APPLICATION FOR A CONDITIONAL USE PERMIT FOR EARTH MATERIALS EXTRACTION – MSB 17.30

Facility/Business Name: Big Dipper Pit

Earth Materials Extraction Permit Narrative
Big Dipper Construction Pit

The Boutet Company, Inc. 601 E. 57th Place #102 Anchorage, AK 99518 Ph. 907-522-6776 License No. AEC0957	SEAL	BIG DIPPER, FAIRVIEW LOOP WASILLA, ALASKA 4101 E. FAIRVIEW LOOP WASILLA, ALASKA SITE PLAN AND PHASES 2 - 9	SHEET 3 / 9
	CONSULTANT	DATE: 12/19/2024	HORZ SCALE: 1"=50' VERT SCALE: N/A

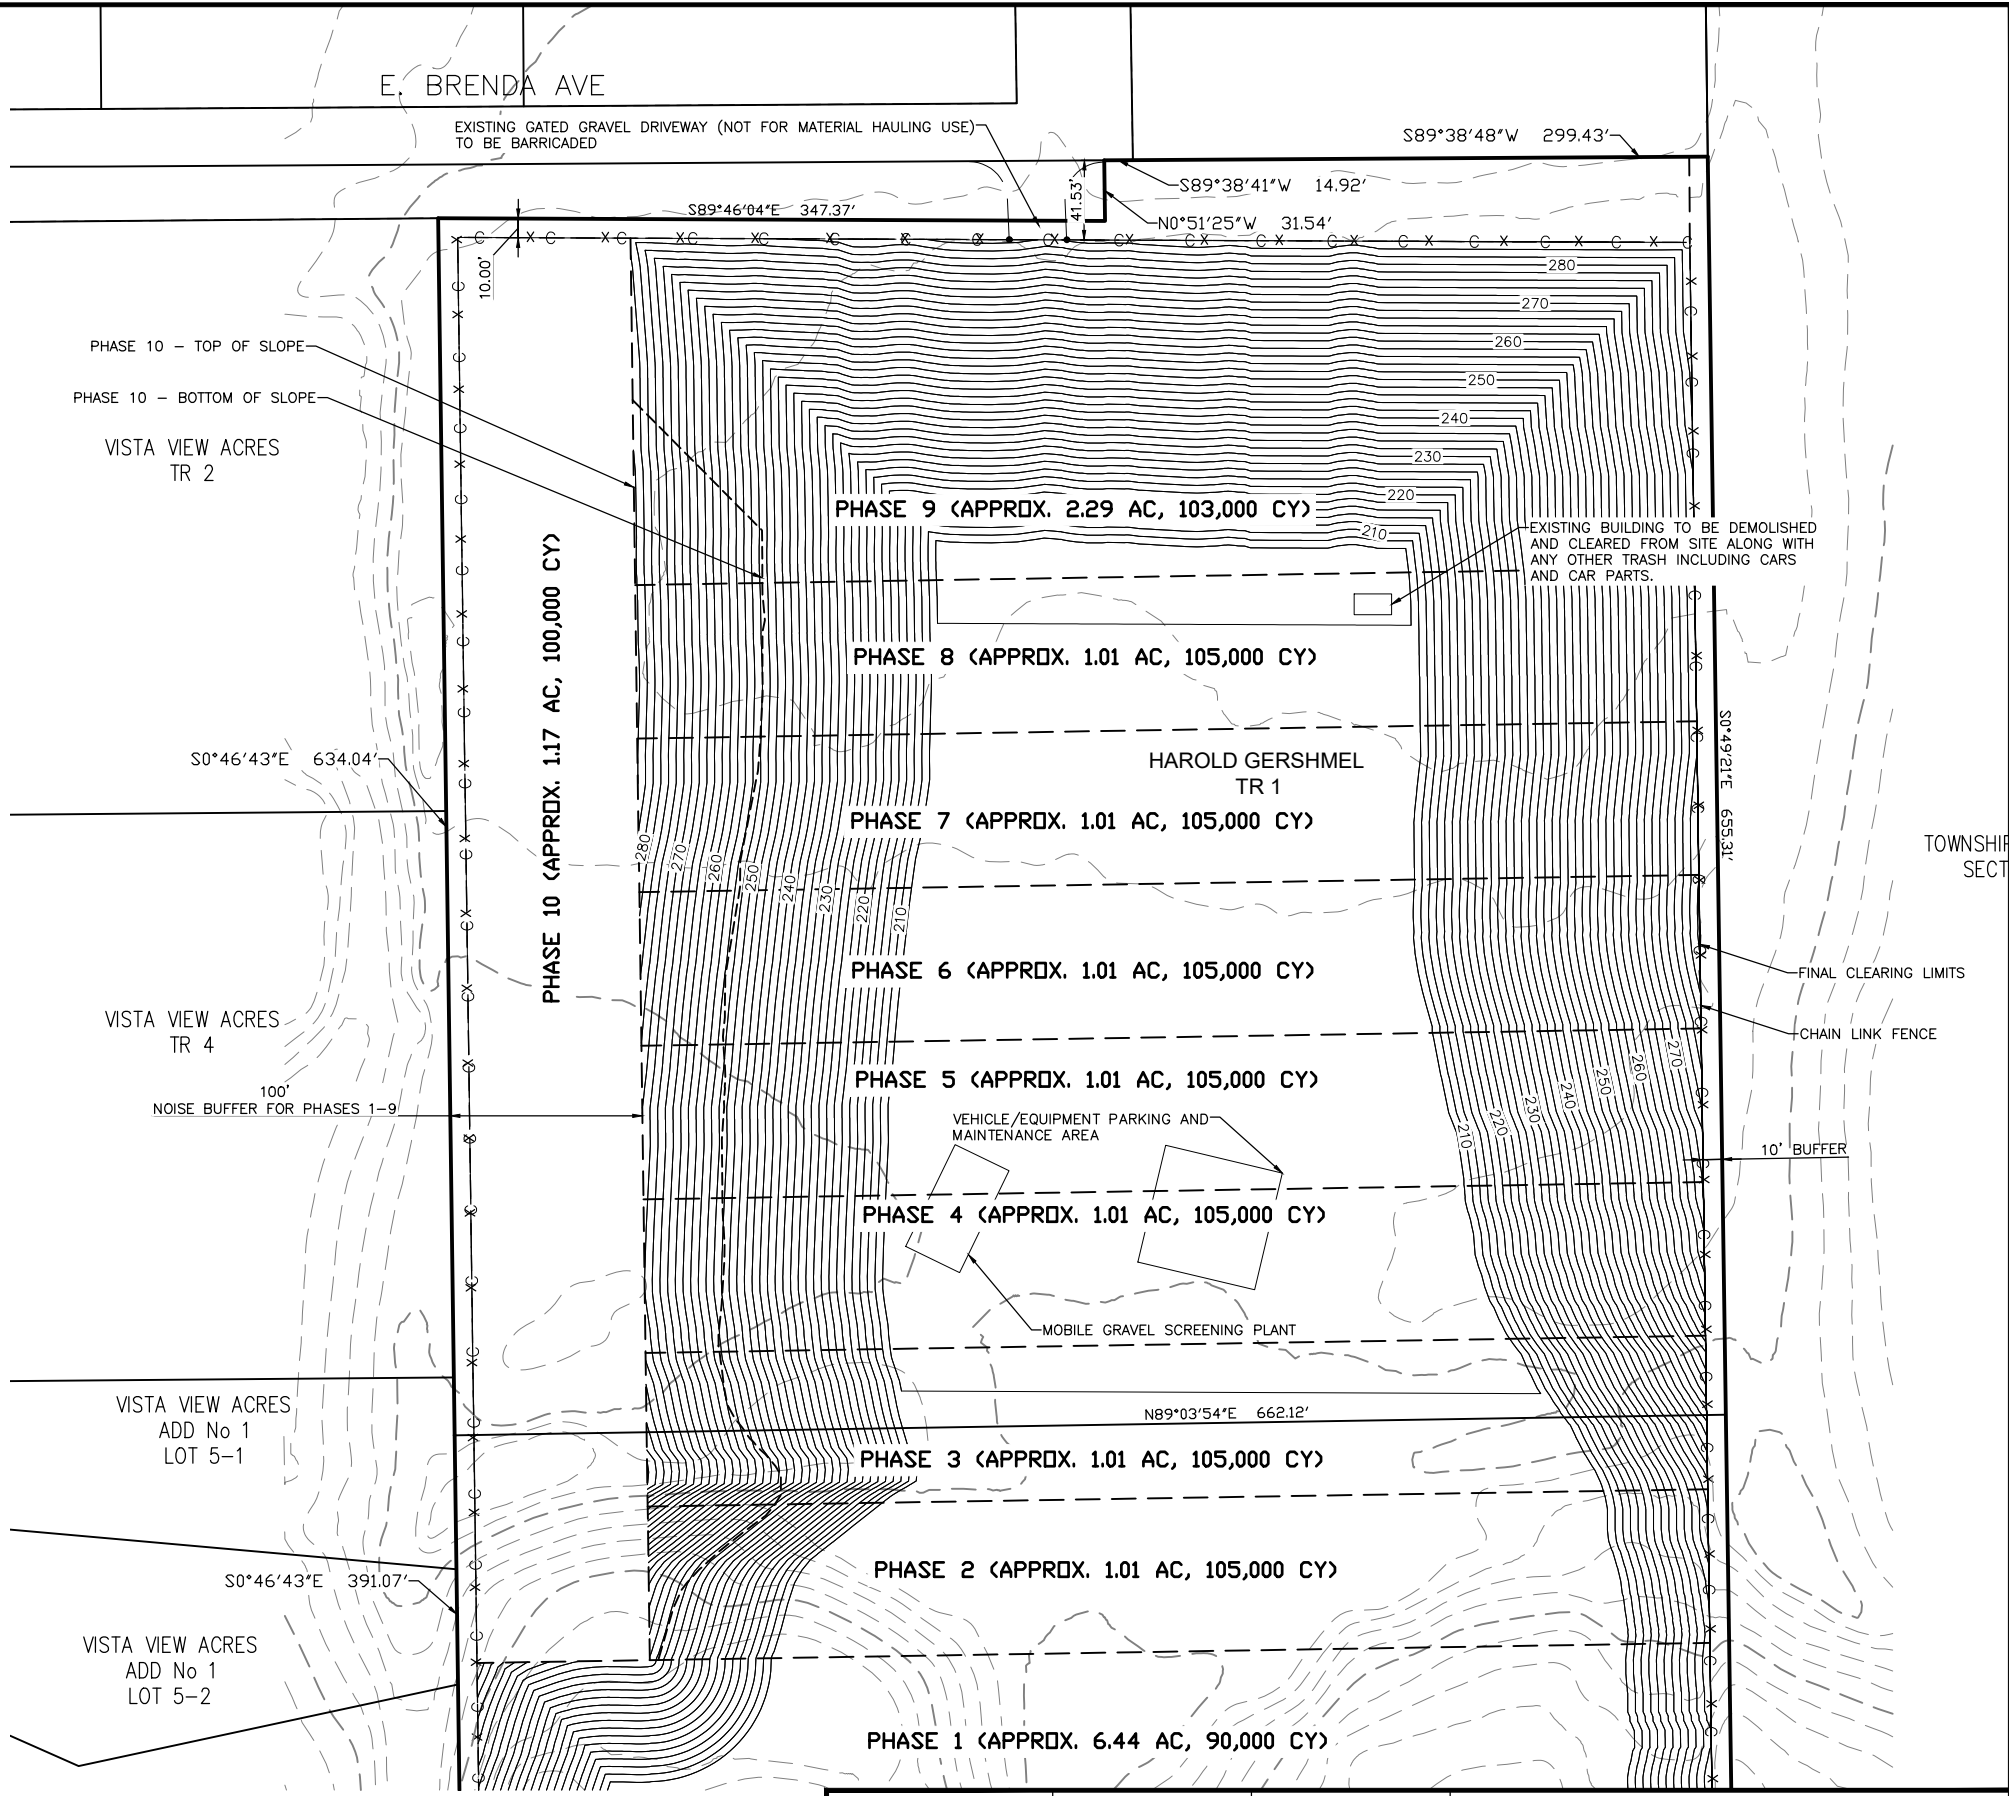
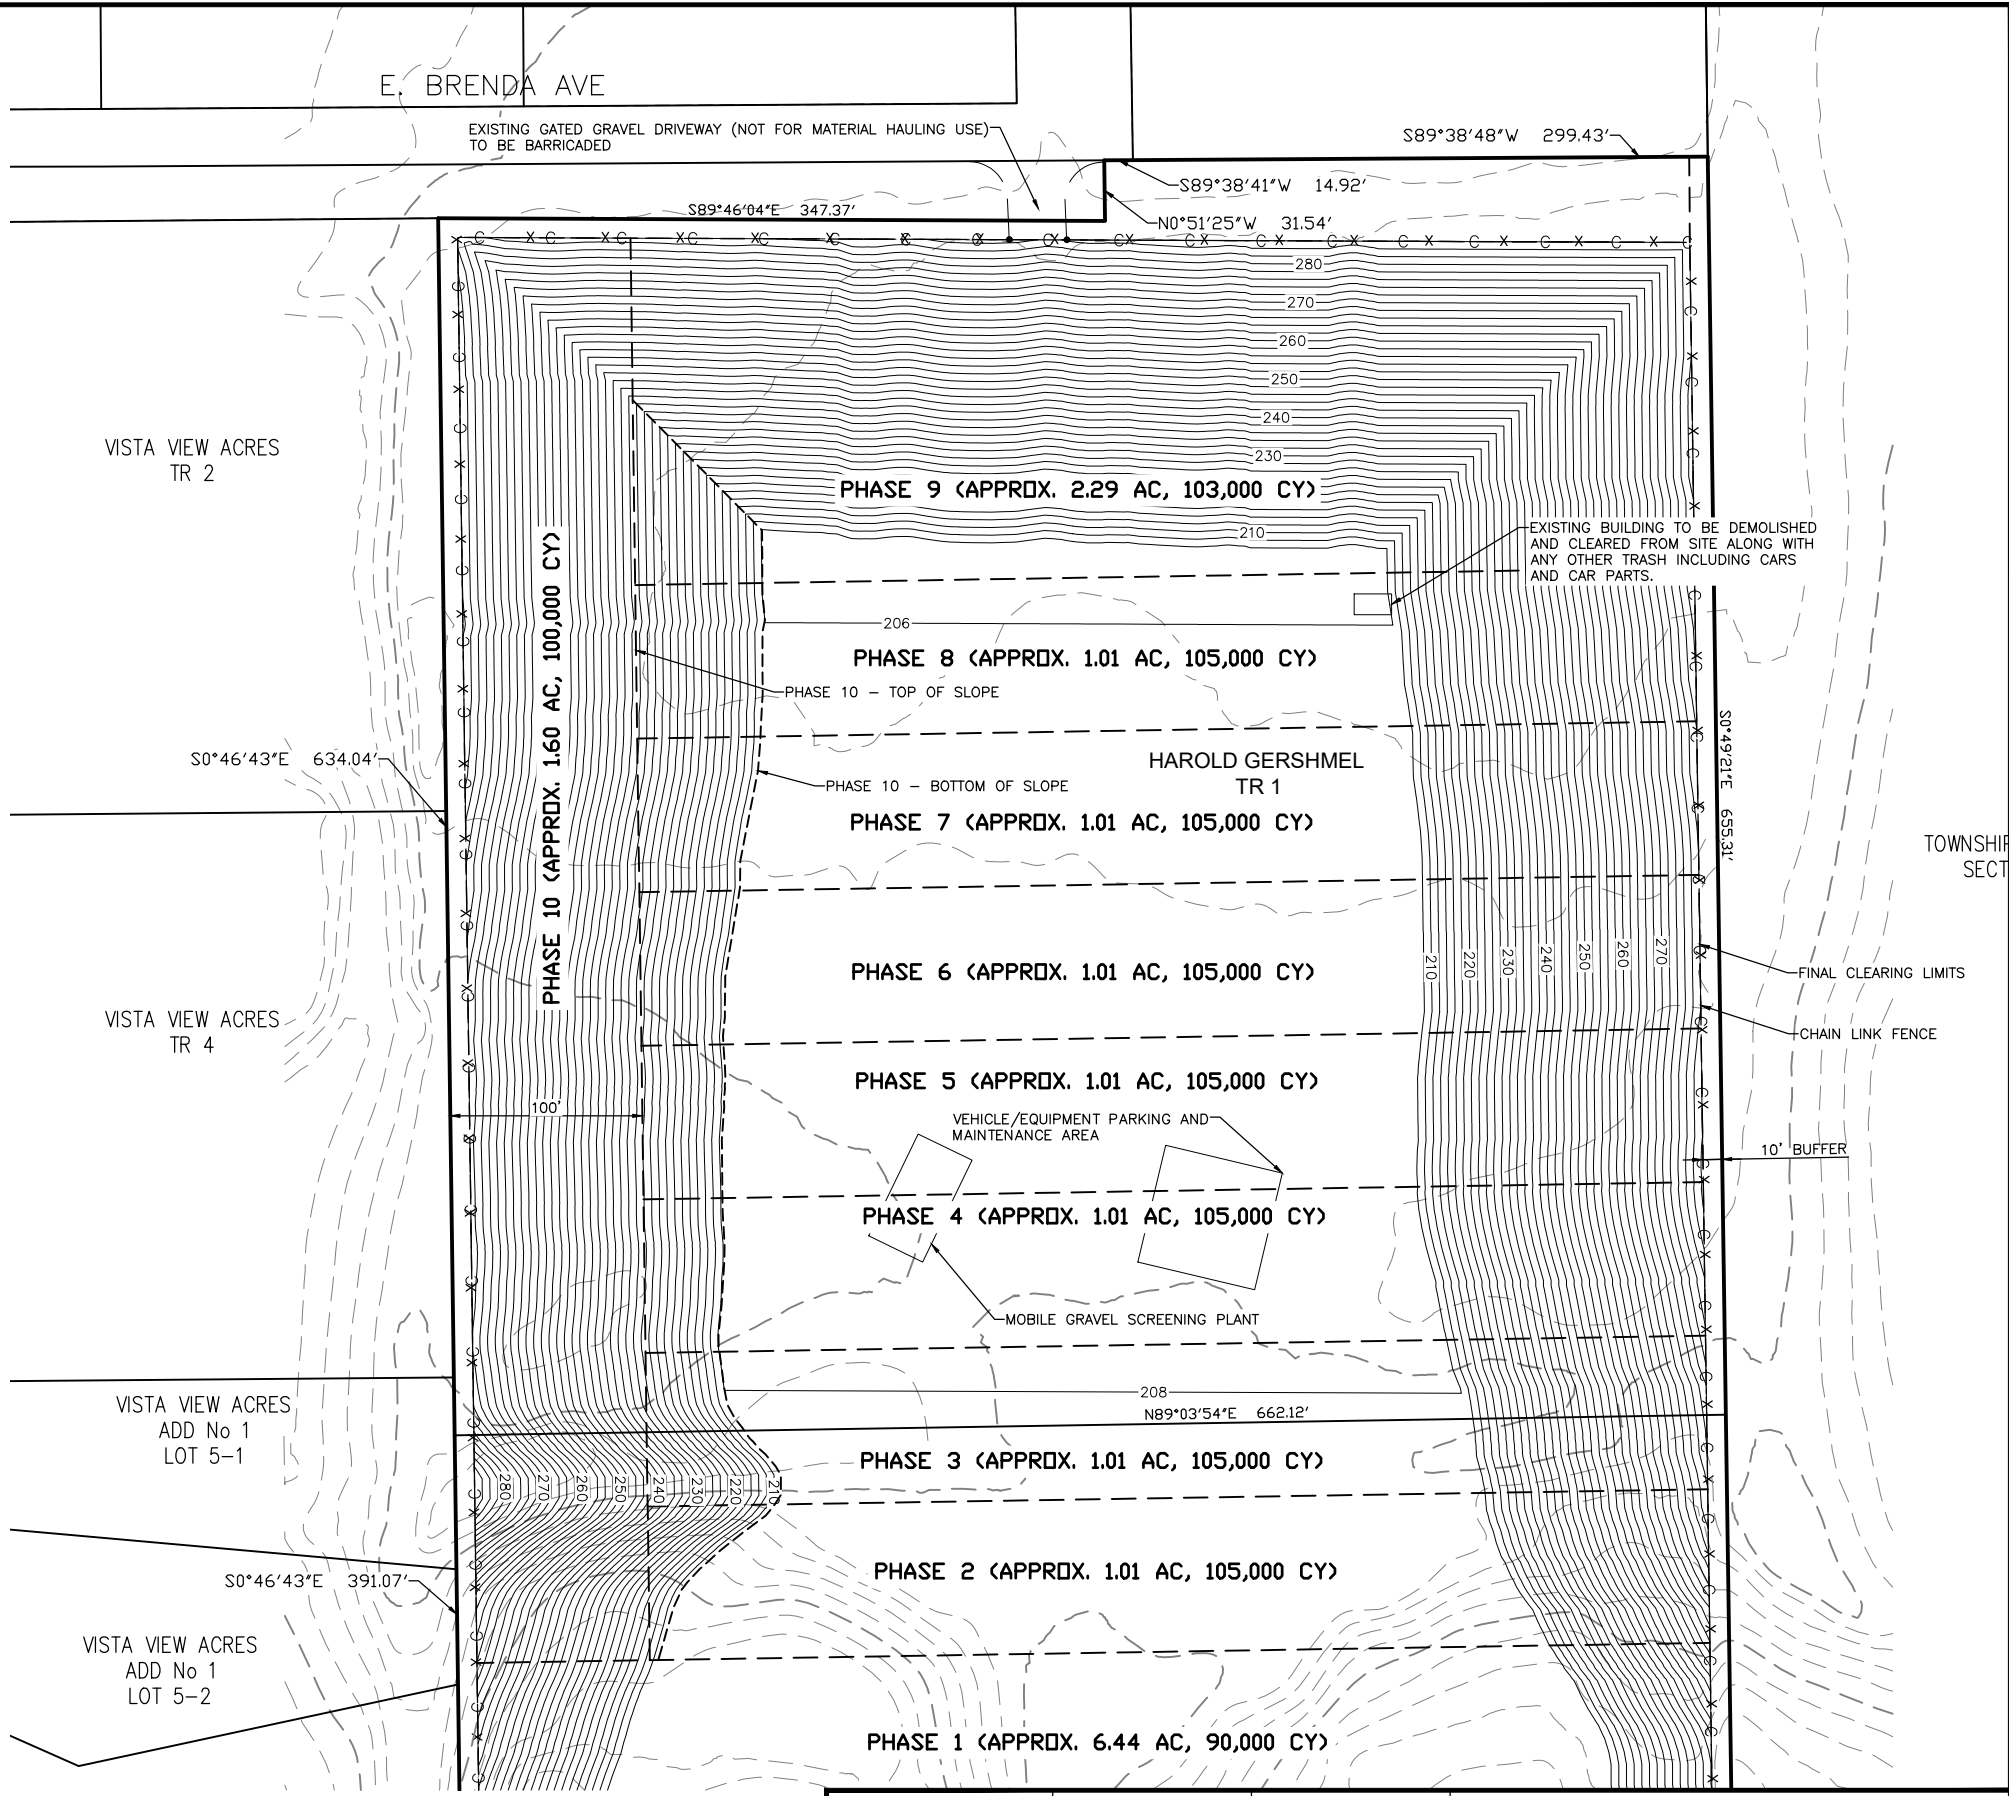
- a. Phase 10 appears to overlap phases 1-9. The "Site Plan and Phases" plans (sheets 3 & 4) for Phase 10 require updating to include the areas within Phases 1-9.

Response: Phase lines are set at the existing ground. With a 2:1 slope requirement the bottom of slope will extend past the phase lines when necessary. Phase 10 has been redefined to include a top of slope and bottom of slope phase line to help clarify this.

- b. Provide the distance from the northernmost edge of Phase 9 to the abutting residential lot to the northeast.

Response: Provided on page 3 the shortest distance is 41.53'.
